**STAFF REPORT**  
**(Preliminary Plat)**

**CASE NUMBER:** S/D 96-5 ECK 4TH ADDITION

**LOCATION:** South of 13th Street North and east of Hoover (I-235)

**VICINITY MAP:**

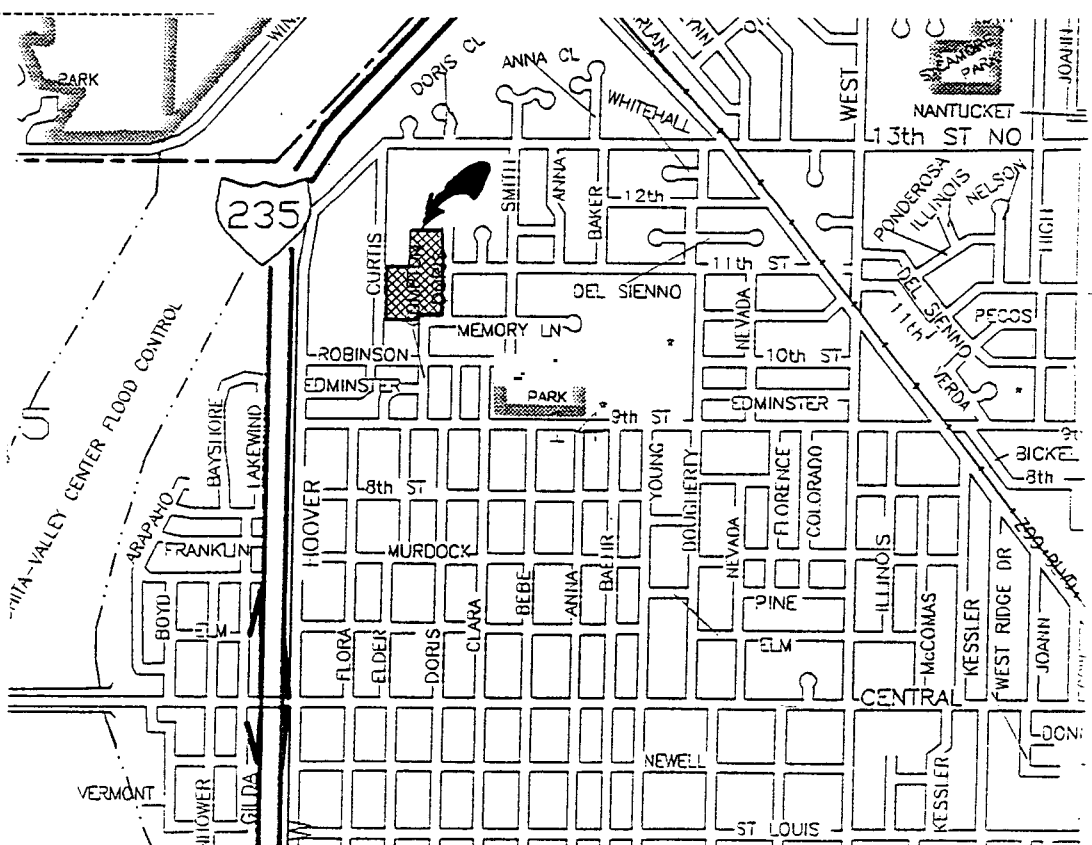
NOTE: While this site is located in an older, developed section of the City, many of the streets in the area are unpaved or were platted or otherwise dedicated with substandard right-of-way widths. This plat is itself showing several sections of only half street right-of-way. In regard to paved, urban-type streets, only Curtis along the plat's western line is apparently paved. Compton which approaches the site from the south, is also paved but only up to where it intersects with Memory Lane. Similarly, 11th Street and Memory Lane immediately east of this site (east of Doris Street) appear to be paved.

- A. The applicant shall guarantee the extension of sanitary sewer to serve the lots being platted.
- B. The applicant shall guarantee the extension of City water to serve the lots being platted.
- C. The applicant shall guarantee any drainage improvements required by the platting of this property.
- D. The applicant shall guarantee construction of the storm sewers required by this plat.
- E. The applicant shall guarantee the paving of all streets adjacent to and/or passing through this site, this including Doris, 11th Street North and Memory Lane. **City Engineering** also needs to confirm the condition of Curtis and if paving of this street is also needed.

In regard to those areas in which only a half street of right-of-way is being shown (Memory Lane adjacent to Lots 15, 16 & 17, Block B and 11th Street adjacent to Lots 5, 6, 7, and 8, Block B), the applicant shall attempt to obtain the dedication of the needed rights-of-way by separate instrument. If the applicant is unable to obtain this right-of-way, he shall request that the City proceed with condemnation of the needed rights-of-way. The costs of any such condemnation may be included in the paving guarantees.

- F. **City Engineering** needs to indicate if a temporary turnaround needs to be provided in the area of Lot 1's Block A northern property line. It should be noted that while Doris extends north of this site, it largely exists only in terms of dedicated right-of-way, ending just north of this site in what basically appears to be a home's private type drive.

- H. In order to provide for the future development of the property to the west and north of this site, and even a further subdivision of this site in the future, it is recommended that the Subdivision Committee and Planning Commission require either the outright or at least contingent dedication of right-of-way for a street along the western line of Lots 1, 2 and 6, Block A. Based on the width of the tracts to the west, a dedication from this site of at least 20-feet would appear to be adequate.

- I. In regard to Lots 1 and 2, Block A, approval of this plat will require a waiver of the lot depth to width ratio of the Subdivision Regulations. The Subdivision Regulations state that, "the maximum depth of all residential lots shall not exceed 2-1/2 times the width thereof."
